CITY OF SWEET HOME PLANNING COMMISSION AGENDA

Staff Report Presented to the Planning Commission

- APPLICANT:** Laura LaRoque, Udell Engineering & Land Surveying, LLC
- PROPERTY OWNER:** Lazar Kalugin, Quality Plus Interiors, LLC
- FILE NUMBER:** VR24-01
- PROPERTY LOCATION:** Sweet Home, OR 97386; Identified on the Linn County Assessor’s Map as 13S01E32CA Tax Lot 4403.
- REVIEW AND DESIGN CRITERIA:** Sweet Home Municipal Code Section(s) 17.10, 17.42.120, 17.58.030, 17.106, and 17.126.
- HEARING DATE & TIME:** September 5, 2024 at 6:30PM
- HEARING LOCATION:** City Hall Council Chamber at 3225 Main Street, Sweet Home, Oregon 97386
- STAFF CONTACT:** Angela Clegg, Planning & Building Manager
Phone: (541) 818-8029; Email: aclegg@sweethomeor.gov
- REPORT DATE:** August 27, 2024

PRELIMINARY LOT PLAN
 TENTATIVE SUBDIVISION
 TAX MAP: 13S01E32CA
 LOT: 04403
 SWETHOME, OREGON

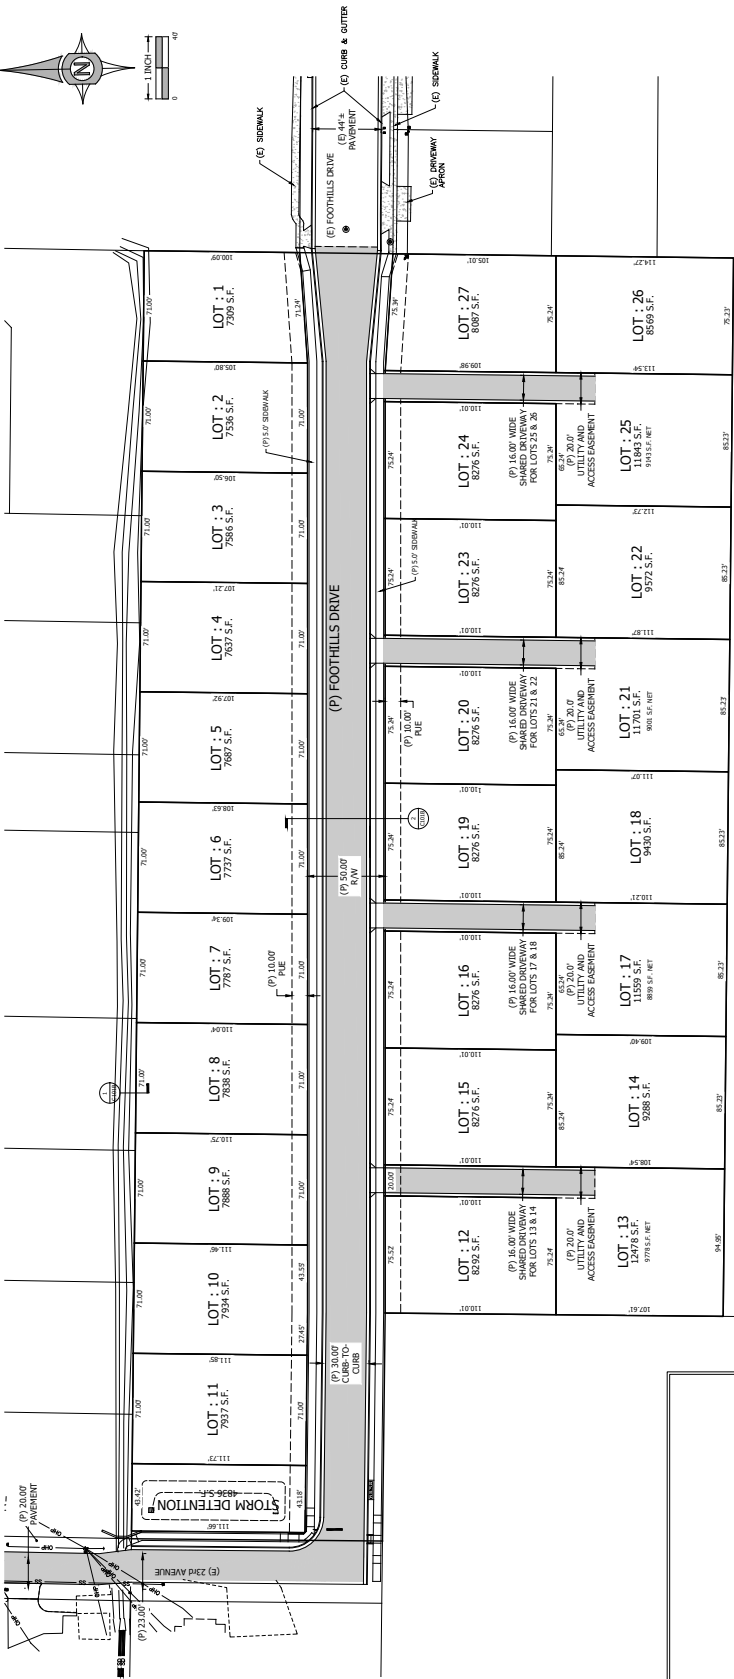
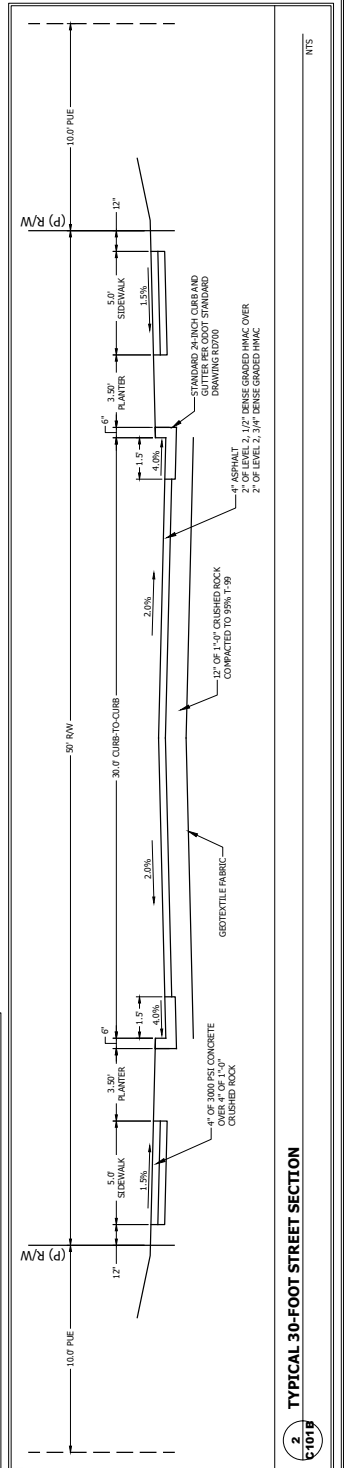
Additional Comments regarding the amended site plan, emailed on August 27, 2024: No utilities are shown, so hopefully they can show me the corrections I needed to see. What's more, it looks to me like our future water tower easement that ran through lots 26 & 27 is completely gone now, additionally, no outlet easement is shown from storm detent to ditch north of the subdivision.

From: [Laura LaRoque](#)
To: [Angela Clegg](#); [Blair Larsen](#)
Subject: QPI alterative lot layout
Date: Saturday, August 24, 2024 7:53:56 AM
Attachments: [23-102 QPI Foothill Alt B.pdf](#)
Importance: High

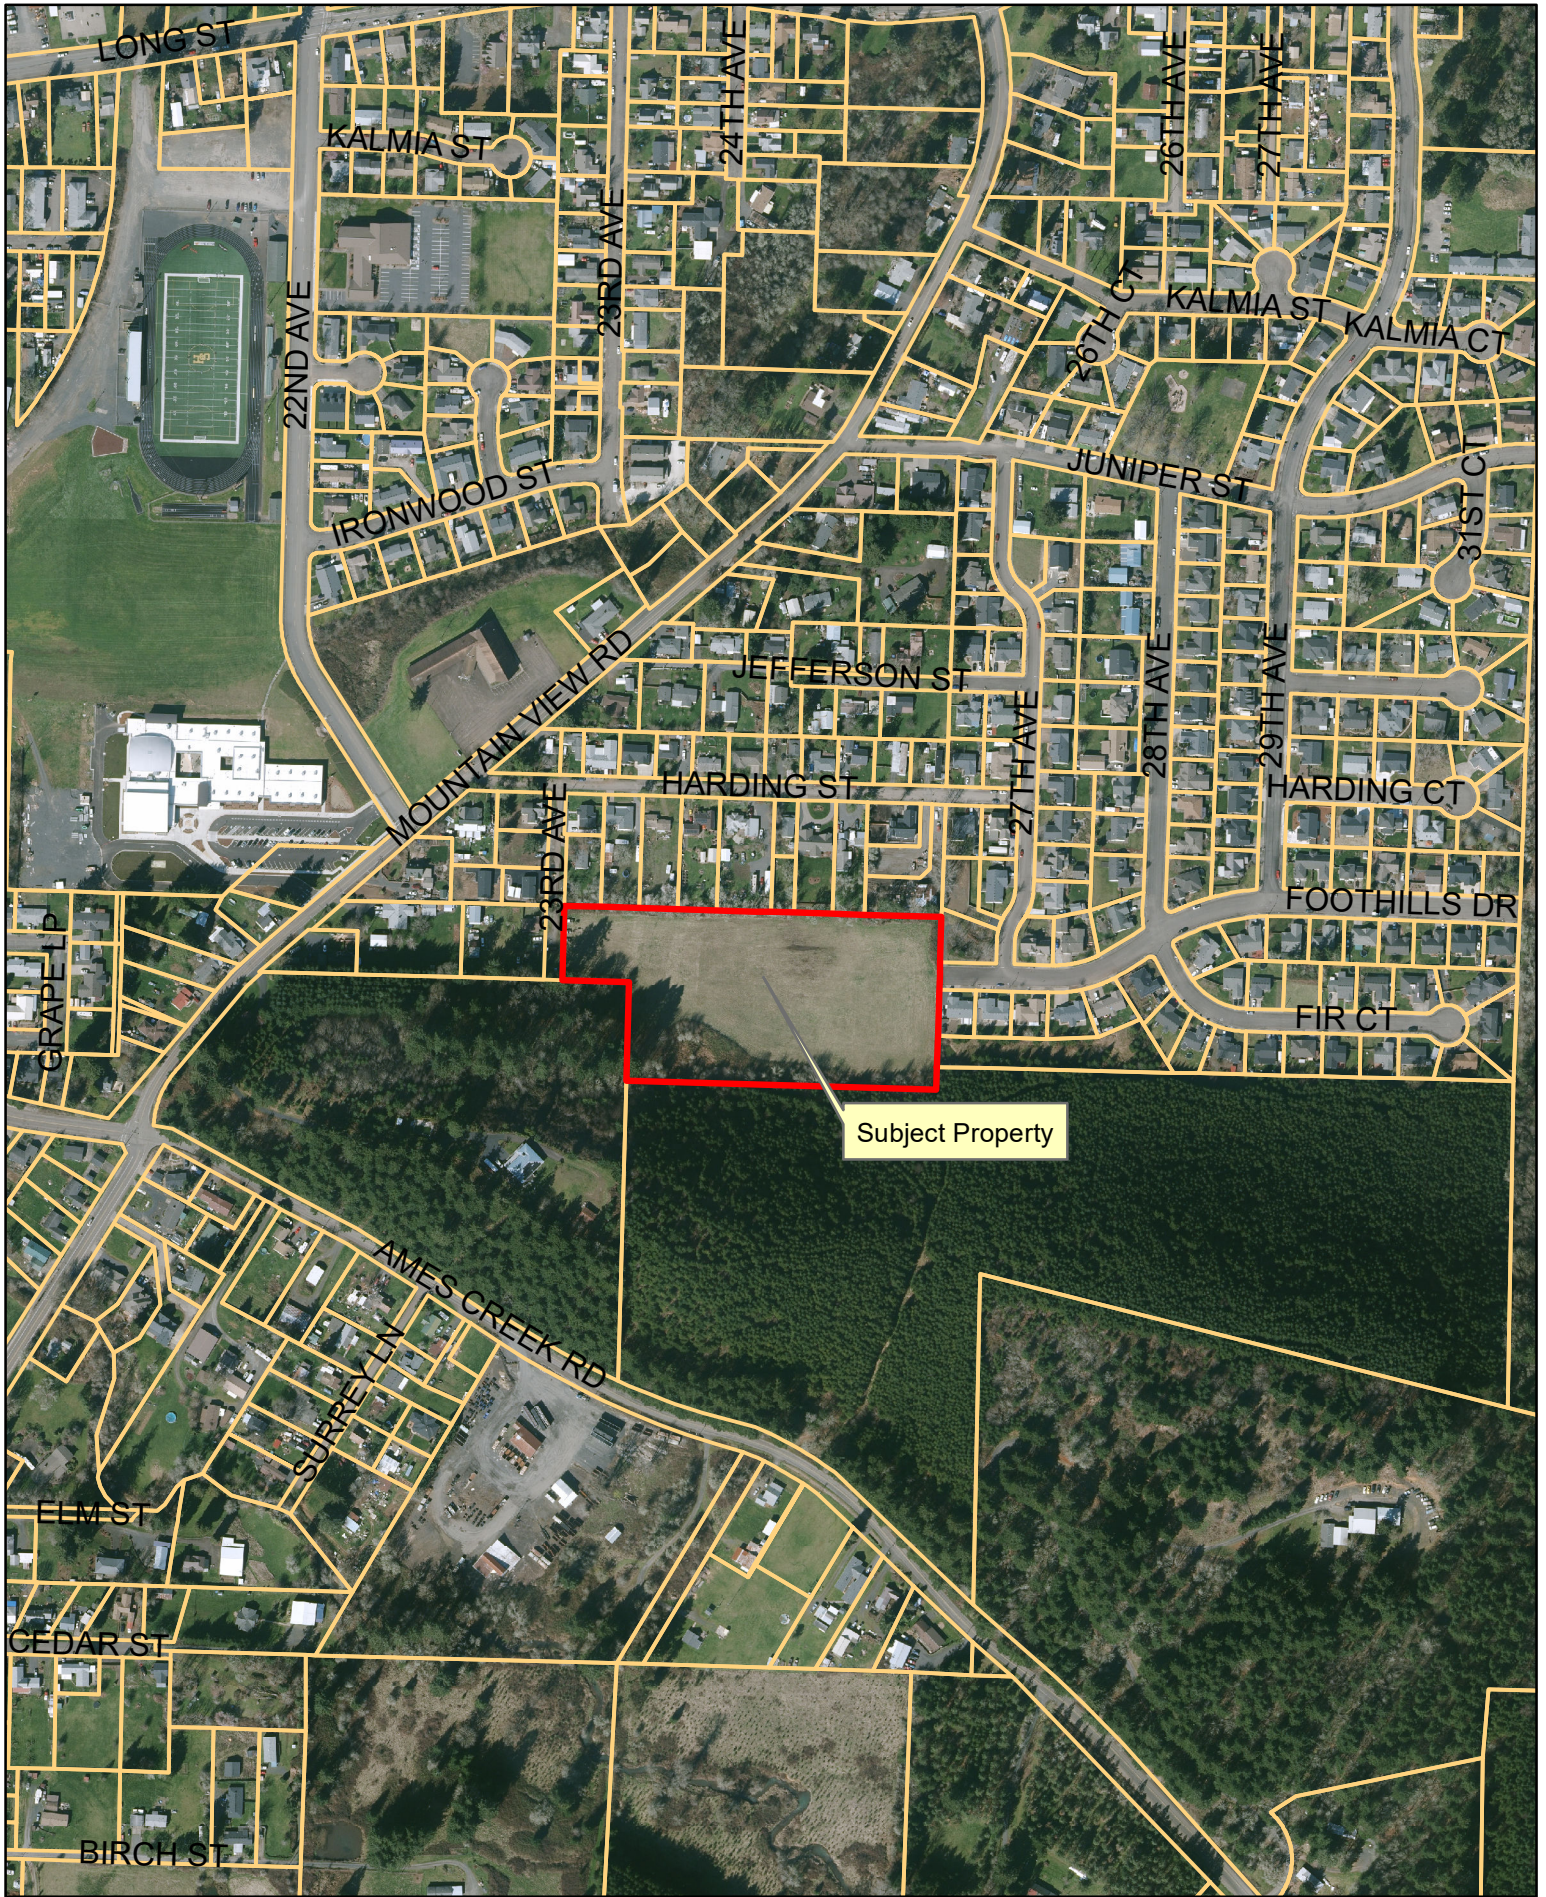
Sorry for the delay on this. Attached is an alternative lot layout for this subdivision. In this layout lots 13, 17, 21, and 25 are flag lots and lots 14, 18, 22, and 26 are access via easement. The 10% standard for subdivision lots accessed via easement is only slightly exceeded in this scenario (3 lots vs. 4 lots proposed and 10% vs 15% proposed). Additionally, the variance request for the lot width measurement is no longer necessary.

We explored a cul-de-sac design as Joe Graybill suggested. However, we then discovered that the Sweet Home development code discourages the use of cul-de-sacs where other reasonable alternatives exist. In this case, we feel that that the attached alterative design is a “reasonable alternative” to a cul-de-sac.

PRELIMINARY LOT PLAN
TENTATIVE SUBDIVISION
TAX MAP: 13S01E32CA
LOT: 04403
SWETHOME, OREGON

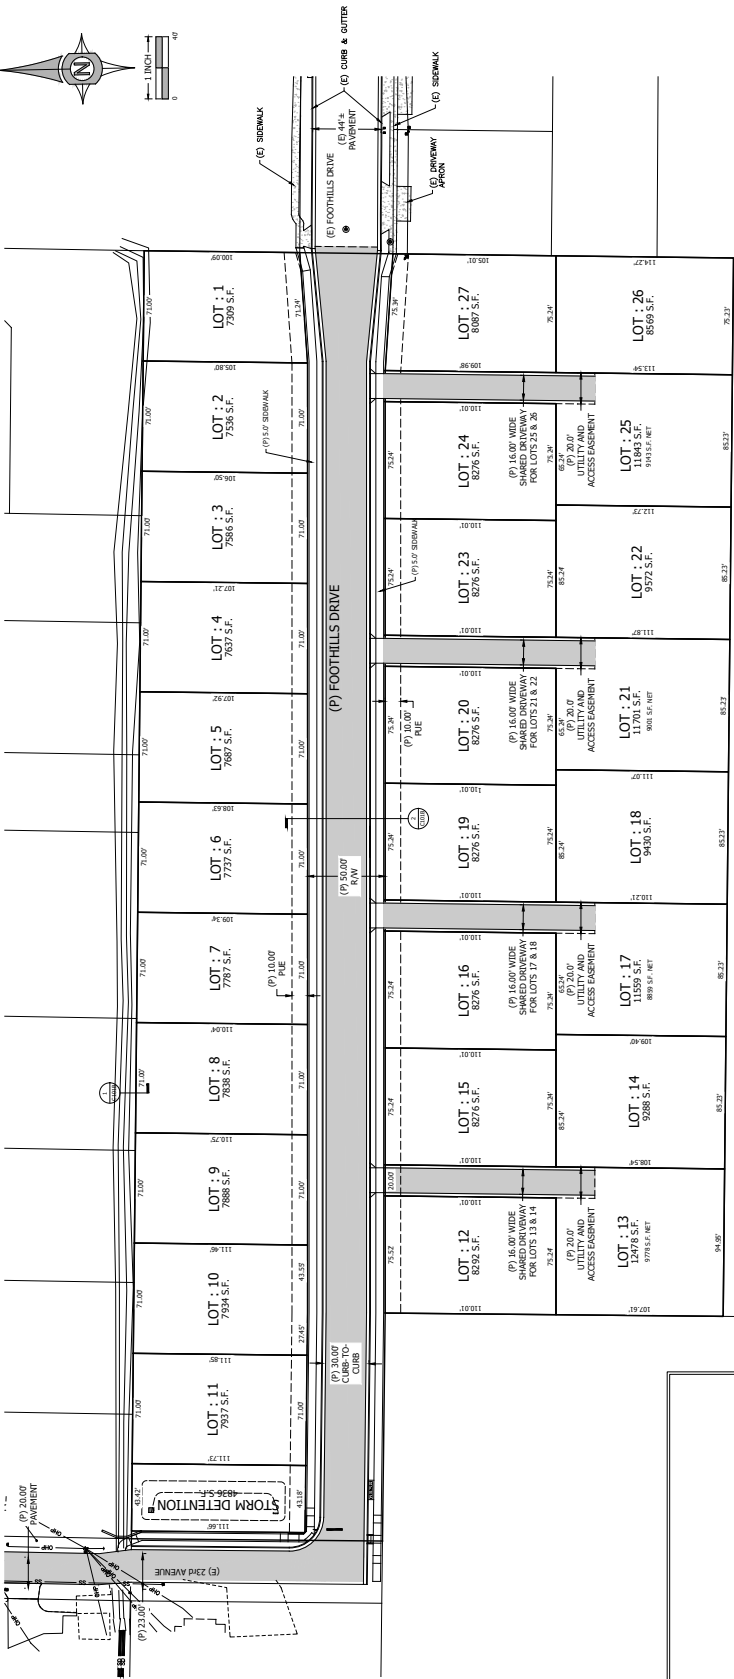
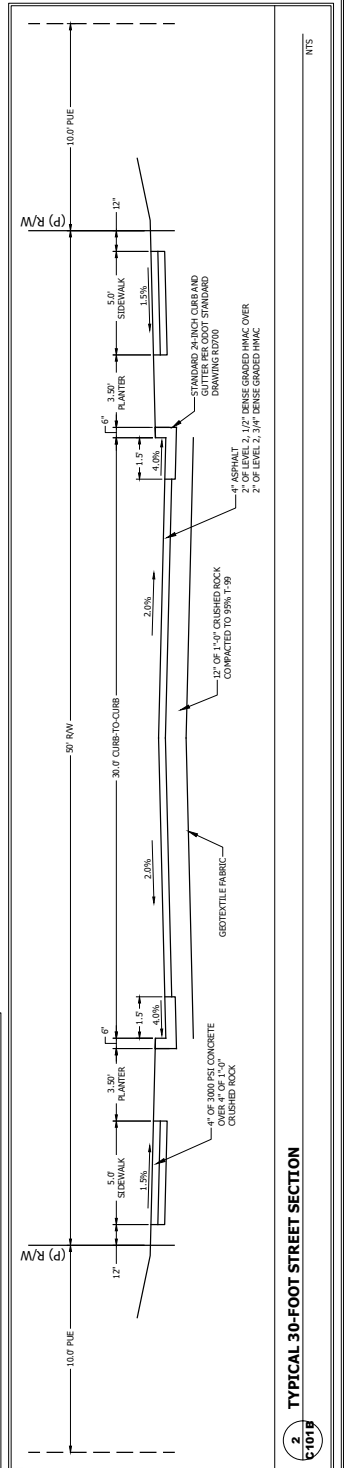
The City of Sweet Home wants to have provision for a waterline easement in the common driveway serving Lot 20 26 on Lot 24 25. The easement would be the same size as the proposed shared utility and access easements as noted on the proposed site plan. The easement would run from the south right-of-way line of Foothills Drive to the south line of Lot 20 25. The City is looking forward 15-20 years to a need for an additional water reservoir in the area, with the adjacent property to the south at the right elevation and location. It has access from Ames Creek Road, so that only a waterline would be connected through the lots. We would likely place a conduit in the ground at the time of construction to feed the future waterline through, without the need for excavation at that future time.

Additional Comments regarding the amended site plan, emailed on August 27, 2024: No utilities are shown, so hopefully they can show me the corrections I needed to see. What's more, it looks to me like our future water tower easement that ran through lots 26 & 27 is completely gone now, additionally, no outlet easement is shown from storm detent to ditch north of the subdivision.

Staff Findings: The proposed site plan (Attachment B C) shows an access and utility easement serving Lot ~~20~~ 26 on Lot 24 25, terminating ~~at the rear lot line of Lot 24 just south of the north boundary line of Lot 25.~~ The City of Sweet Home recommends a provision for a public waterline easement in the common driveway serving Lot ~~20~~ 26 on Lot 24 25, extending to the rear lot line of Lot ~~20~~ 25. The easement would run from the south ROW line of Foothills Drive to the south line of Lot ~~20~~ 25. The City is looking forward 15-20 years to a need for an additional water reservoir in the area, with the adjacent property to the south at the right elevation and location. It has access from Ames Creek Road, so that only a waterline would be connected through the lots. We would likely place a conduit in the ground at the time of construction to feed the future waterline through, without the need for excavation at that future time.

The proposed site plan (Attachment B C) shows an access and utility easement serving Lot 20 26 on Lot 24 25. The City of Sweet Home recommends a provision for a waterline easement in the common driveway serving Lot 20 26 on Lot 24 25. The easement would run from the south ROW line of Foothills Drive to the south line of Lot 20 25. The City is looking forward 15-20 years to a need for an additional water reservoir in the area, with the adjacent property to the south at the right elevation and location. It has access from Ames Creek Road, so that only a waterline would be connected through the lots. We would likely place a conduit in the ground at the time of construction to feed the future waterline through, without the need for excavation at that future time.

From: [Laura LaRoque](#)
To: [Angela Clegg](#); [Blair Larsen](#)
Subject: QPI alternative lot layout
Date: Saturday, August 24, 2024 7:53:56 AM
Attachments: [23-102 QPI Foothill Alt B.pdf](#)
Importance: High

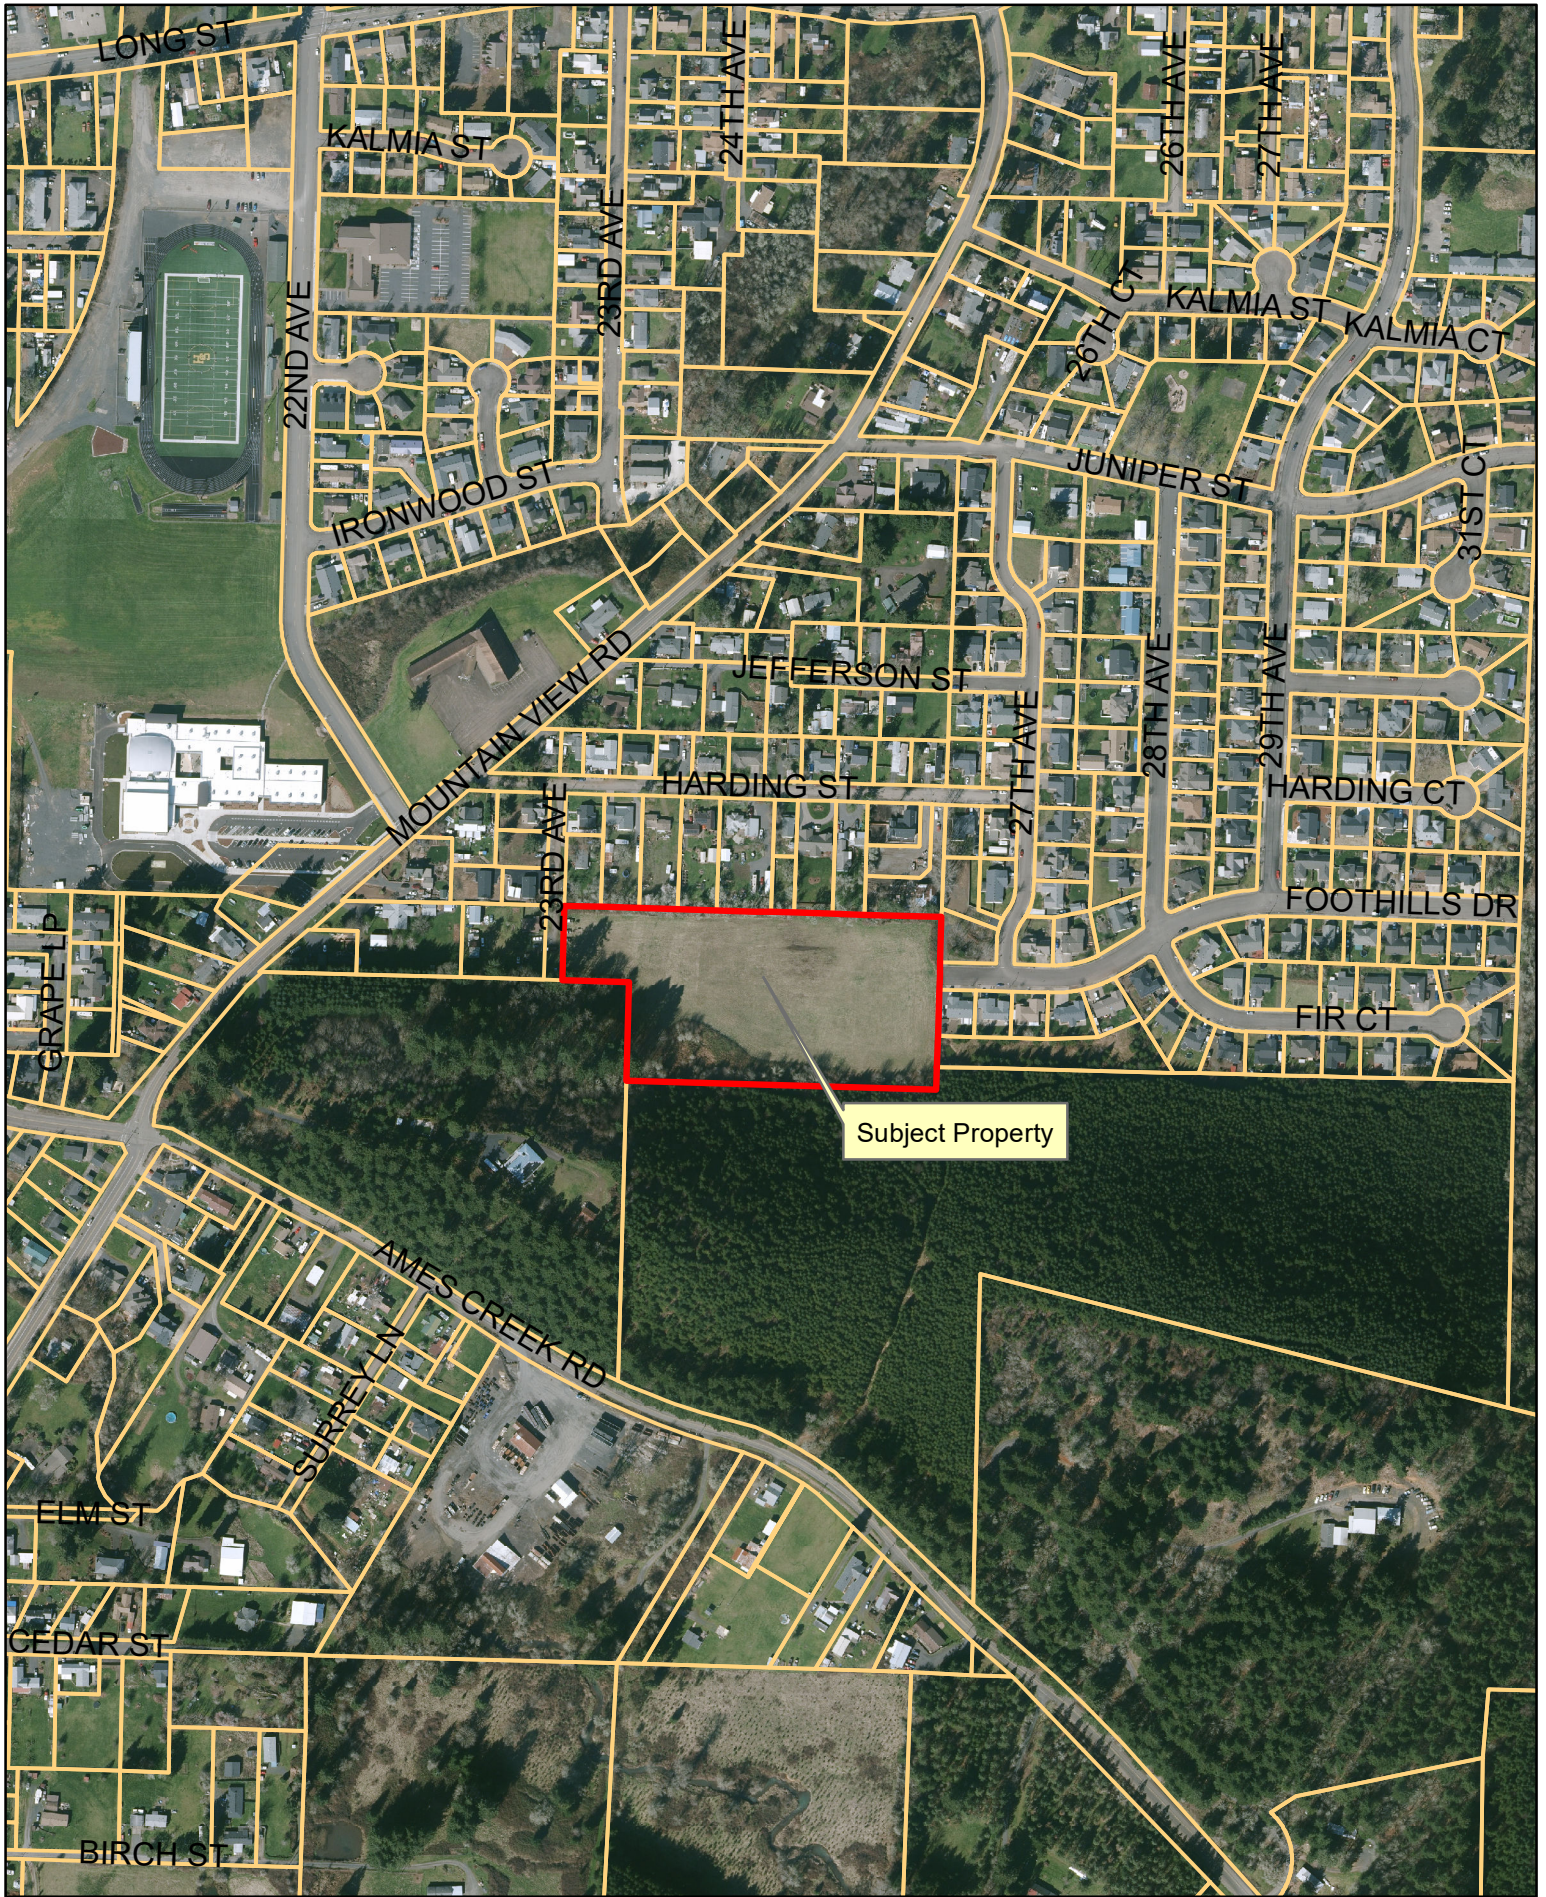
Sorry for the delay on this. Attached is an alternative lot layout for this subdivision. In this layout lots 13, 17, 21, and 25 are flag lots and lots 14, 18, 22, and 26 are access via easement. The 10% standard for subdivision lots accessed via easement is only slightly exceeded in this scenario (3 lots vs. 4 lots proposed and 10% vs 15% proposed). Additionally, the variance request for the lot width measurement is no longer necessary.

We explored a cul-de-sac design as Joe Graybill suggested. However, we then discovered that the Sweet Home development code discourages the use of cul-de-sacs where other reasonable alternatives exist. In this case, we feel that that the attached alternative design is a “reasonable alternative” to a cul-de-sac.
